Our Ref: 24BRT0528
MEDQ Ref: DEV2024/1590

**RE: Proposed Commercial Development, 8-18 Jamieson Street, Bowen Hills
Response to EDQ Further Issues (DEV2024/1590)**

Attachment A Revised Architectural Plans

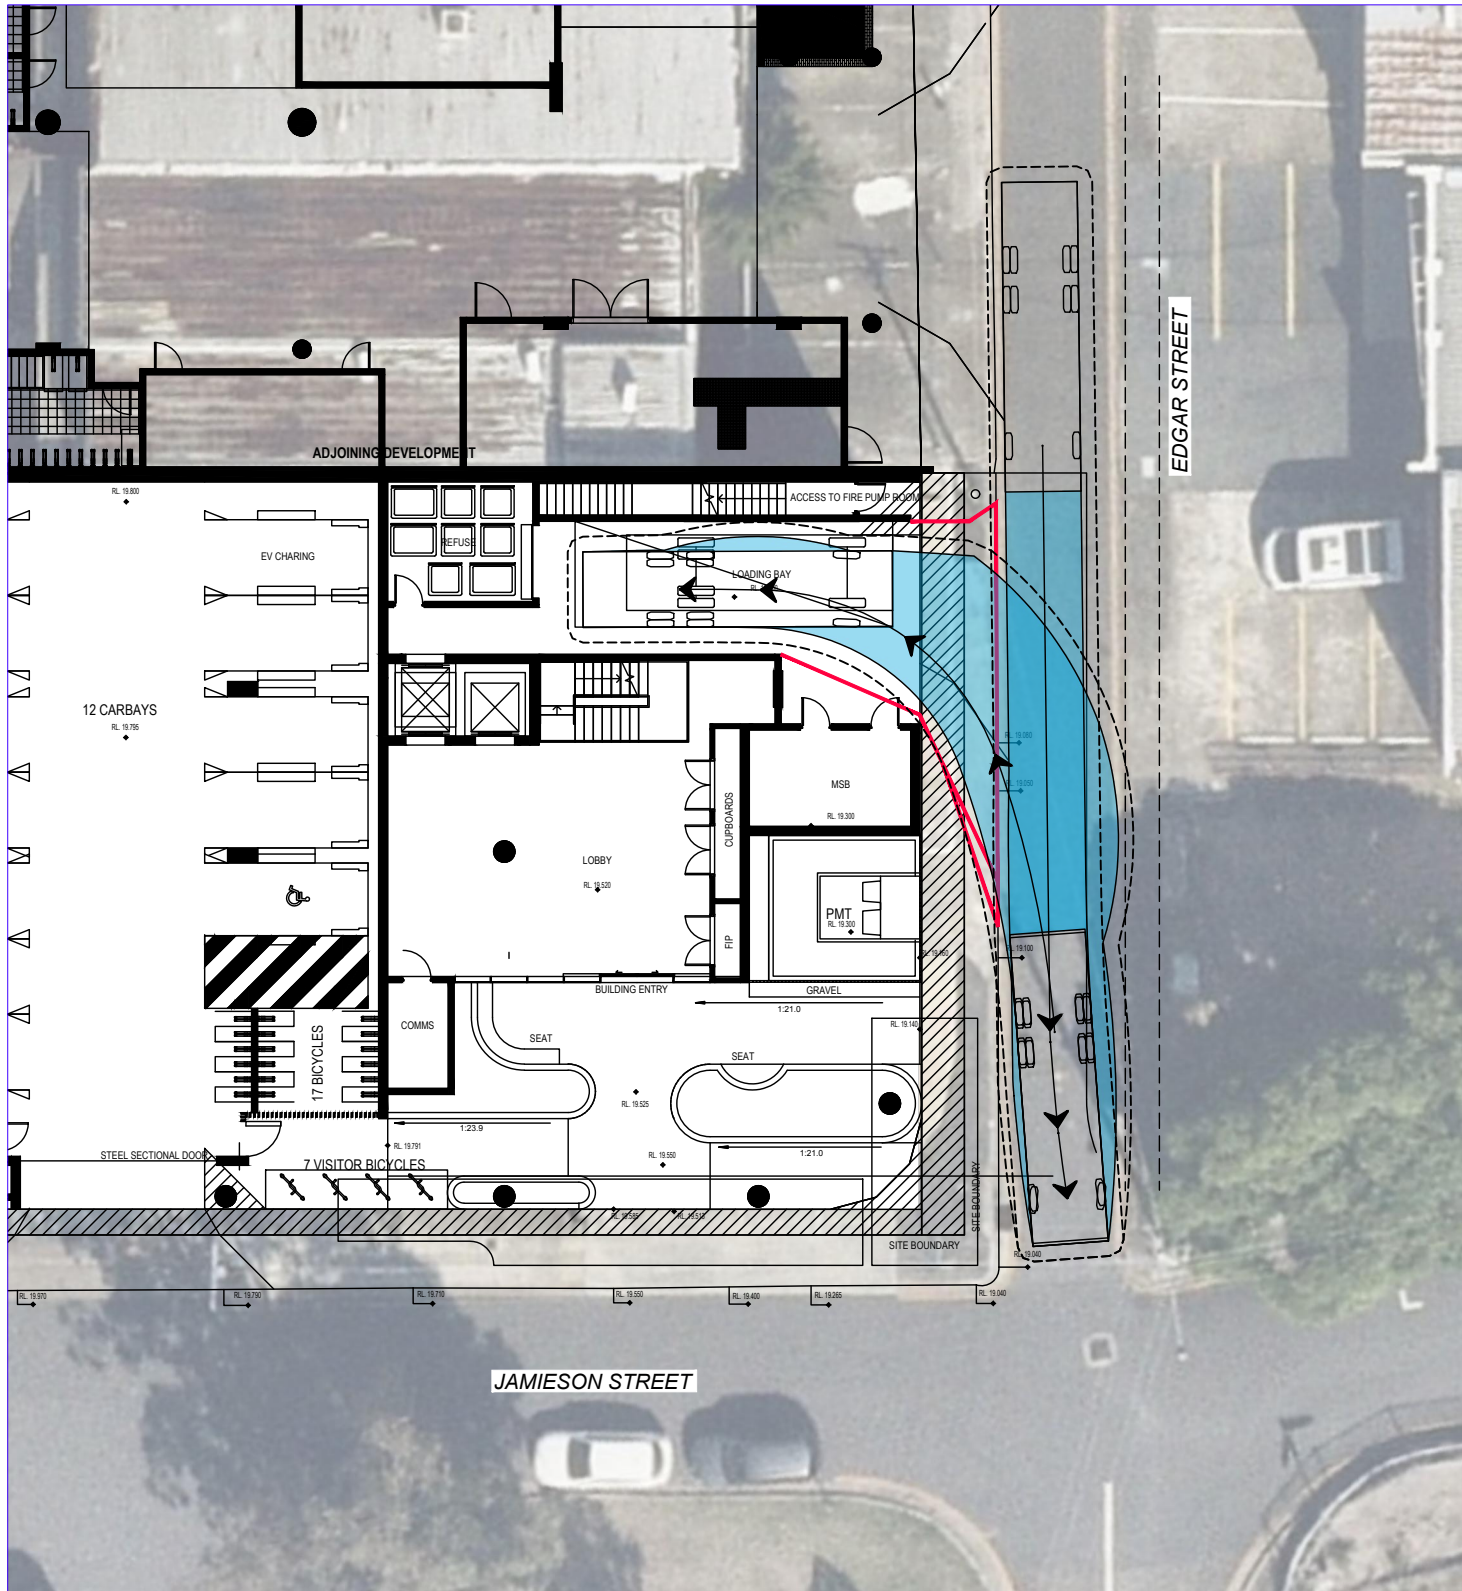
Provide amended plans that relocate the car parking space for PWD to closest point possible to the building entrance.

Provide details on how the development, in accordance with the Scheme, provides EV charging bays and associated infrastructure.

Provide details on how the development, in accordance with the Scheme, provides bicycle parking spaces for employees and visitors along with the necessary end of trip facilities, being lockers and showers. Visitor bike parking spaces are to be in locations accessible to the public.

The revised architectural plans, prepared by nettletontribe and included as **Attachment A** to this response, illustrate the proposed development's single Persons with a Disability (PWD) space in the closest possible location for pedestrian access to the building lobby – northern car parking row, closest to Jamieson Street.

The internal layout of the Ground Level car park, accessible via Jamieson Street, has been revised to address the PWD and electric vehicle (EV) bay items. As a result of moving the PWD and shared bays closer to the access, along with the staff bicycle parking, the last car space along the northern parking row has a vacant area with 1.25m width adjacent. This area can be utilised for installation of EV fast charging equipment.

The revised architectural plans, prepared by nettletontribe and included as **Attachment A** to this response letter, identify the revised bicycle parking and end-of-trip facilities provisions. This includes:

- 17 employee bicycle spaces.
- Seven (7) visitor bicycle spaces.
- Three (3) shower cubicles – one (1) male, one (1) female, one (1) accessible uni-sex.
- 34 lockers.

DRAWING TITLE
SWEPT PATH ANALYSIS
10.2m REAR LOADING REFUSE COLLECTION VEHICLE

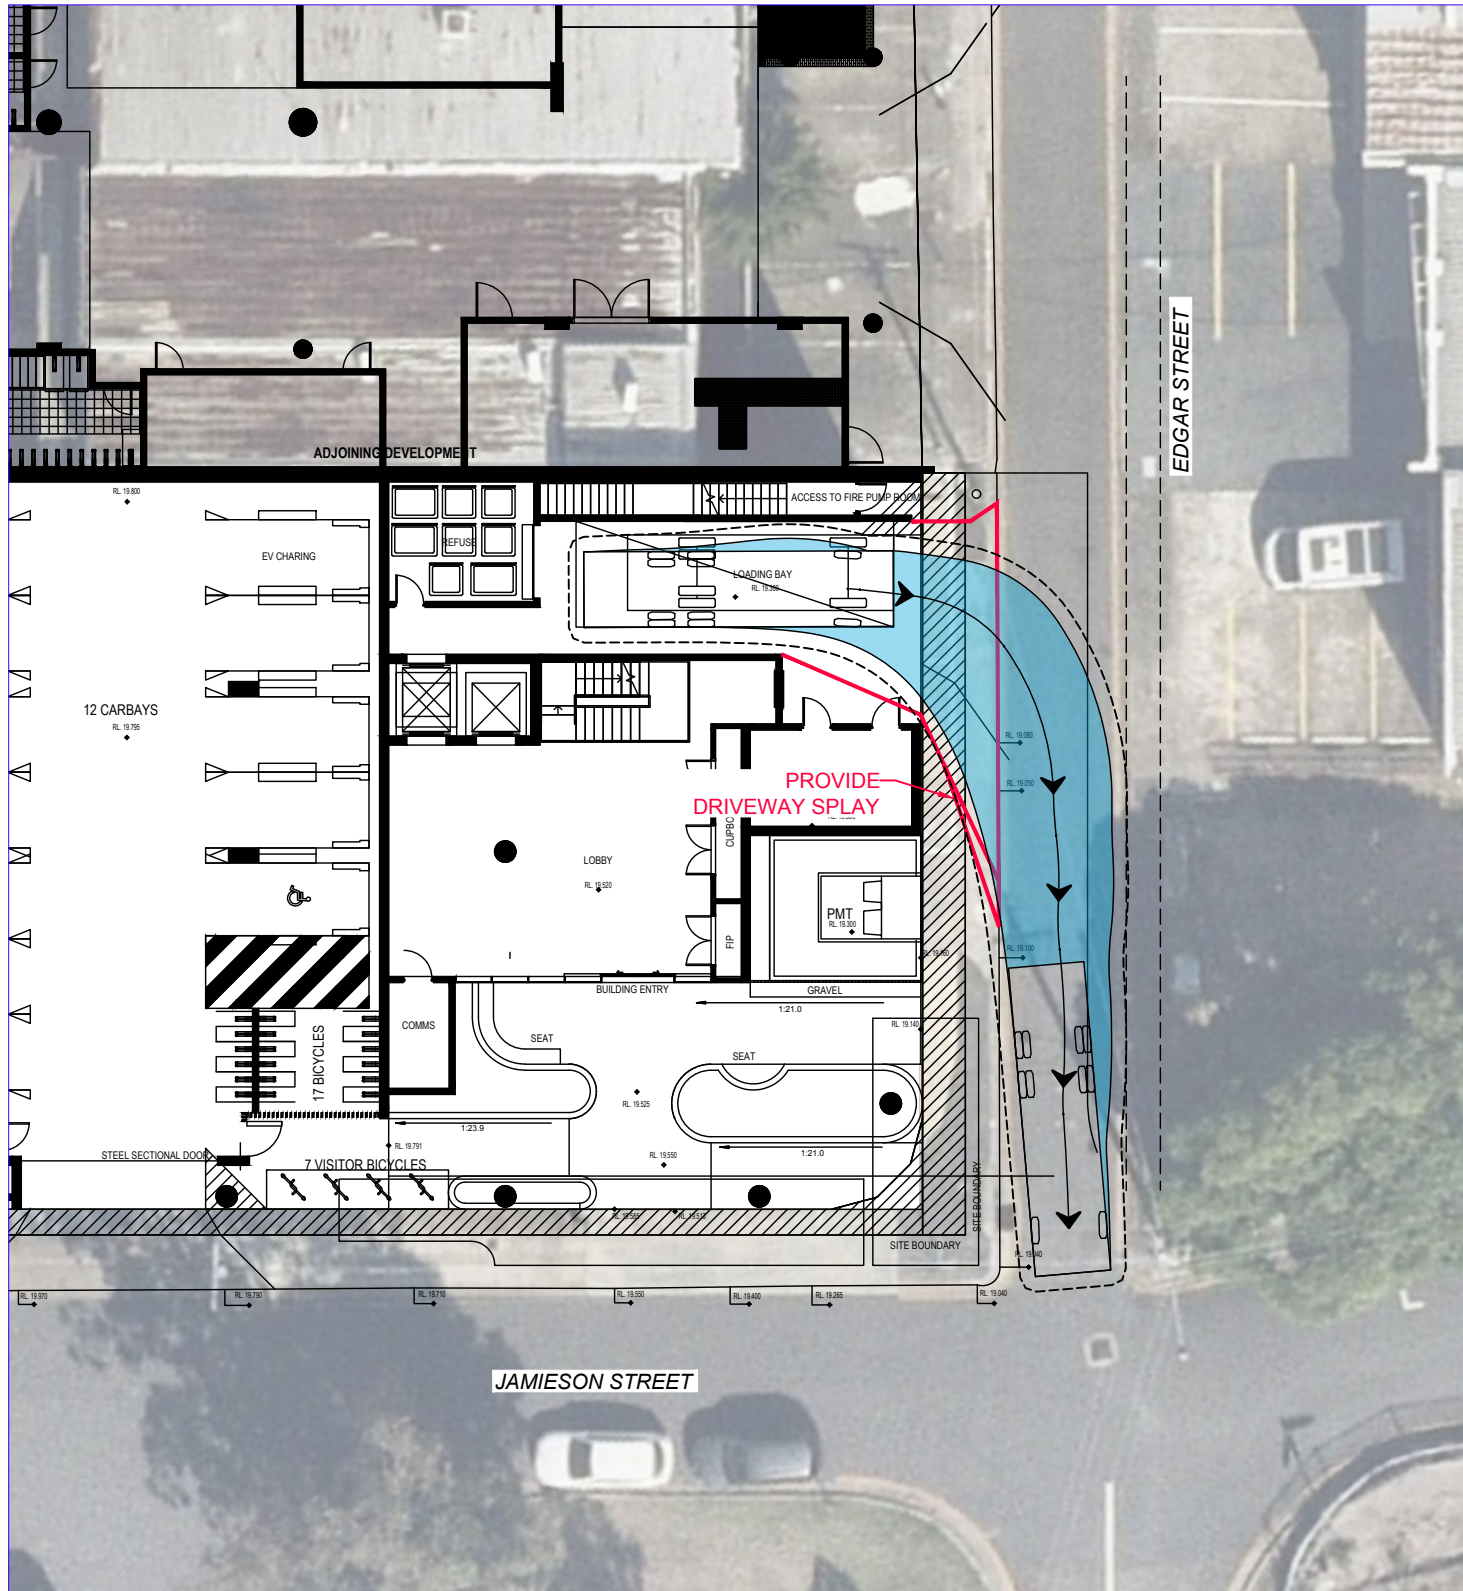
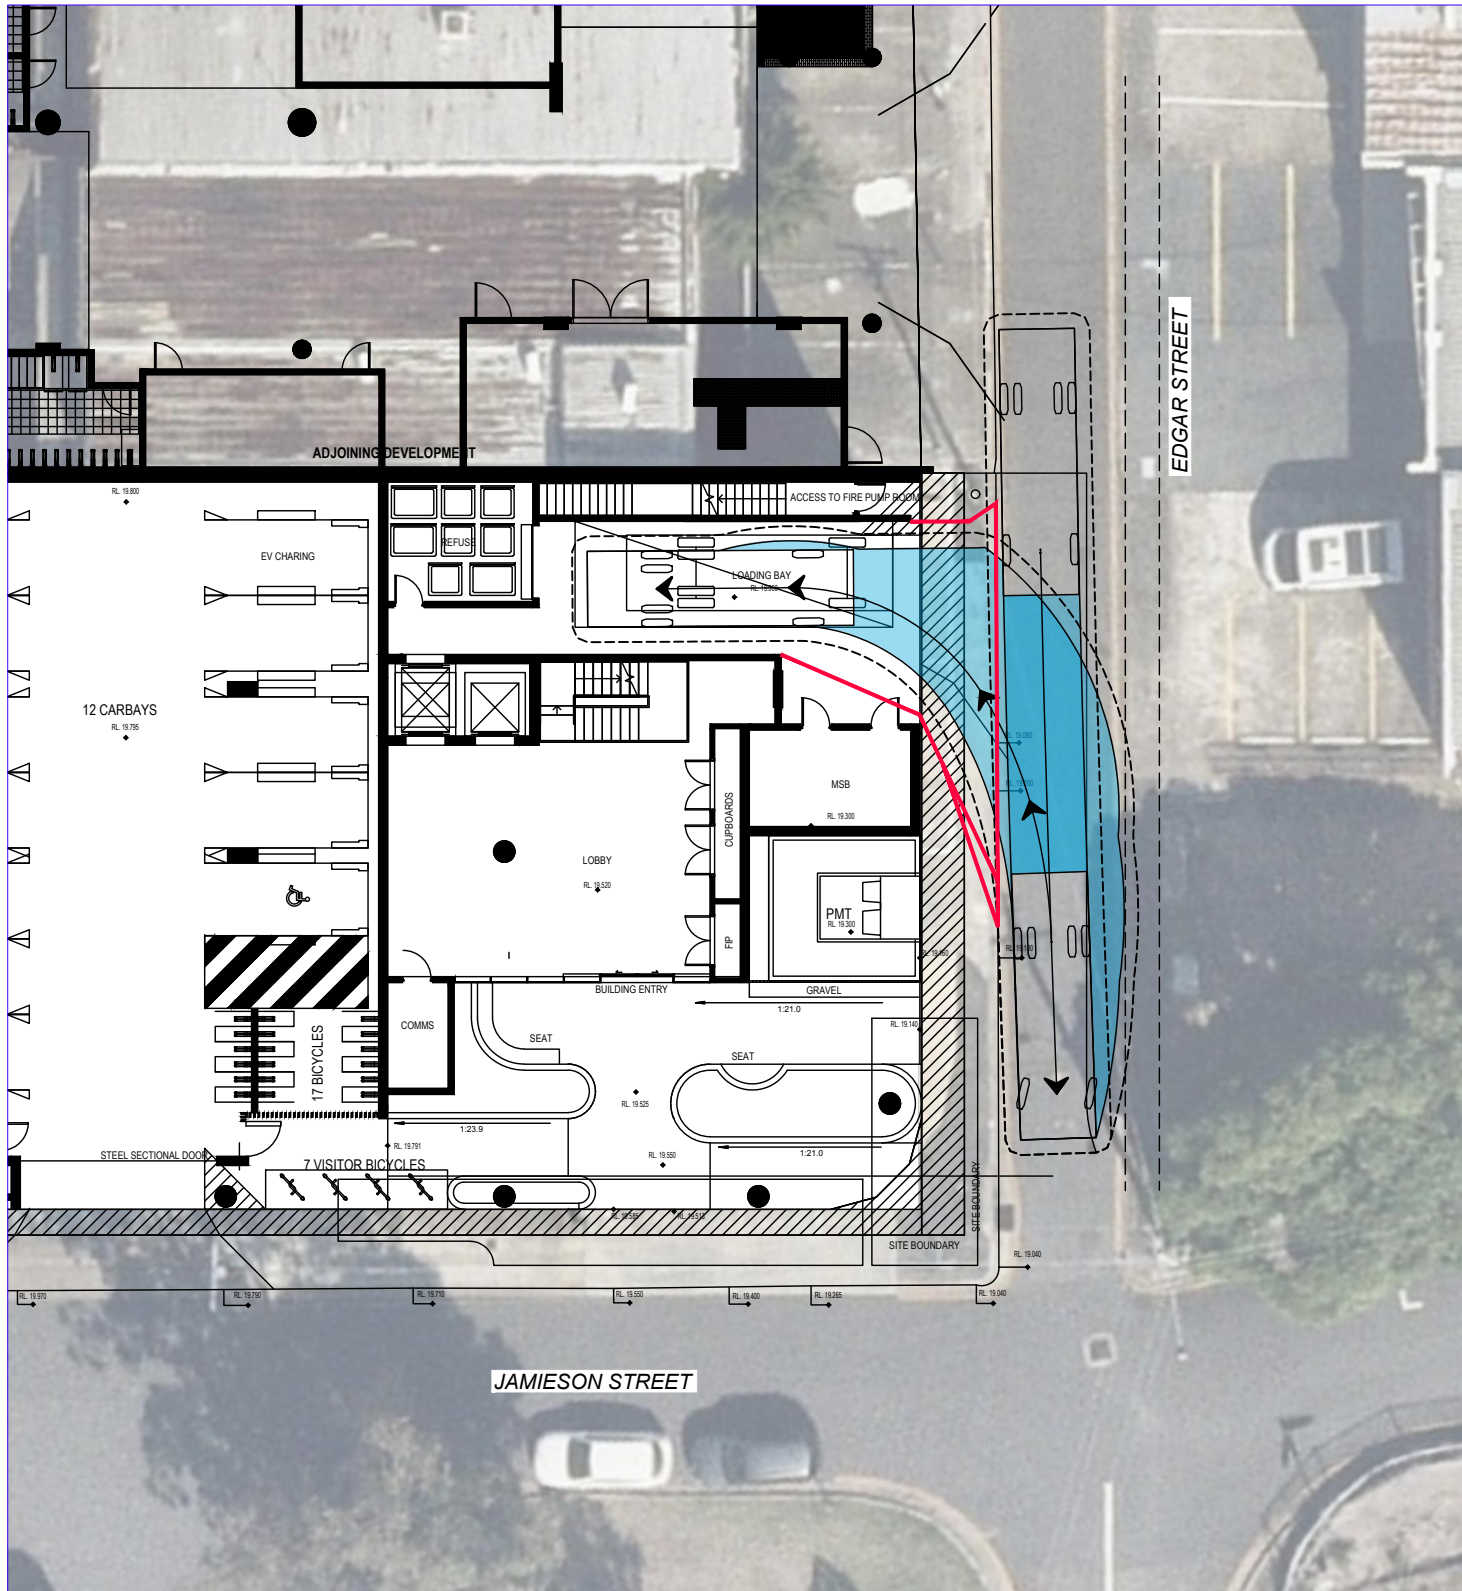
- a. Consistent amended plans which show swept paths confirming no conflict with internal structure and external assets; OR*
- b. Written confirmation from a private contractor that a smaller vehicle can be used to service the site. Where a private contractor is appointed, submit amended plans illustrating revised swept paths for smaller vehicle.*

Revised Colliers Drawings have been prepared based on the latest architectural plans. These are included as **Attachment B** to this response letter and illustrate the identified design service vehicles accessing the designated loading bay, without encroaching any adjacent structures / obstructions.
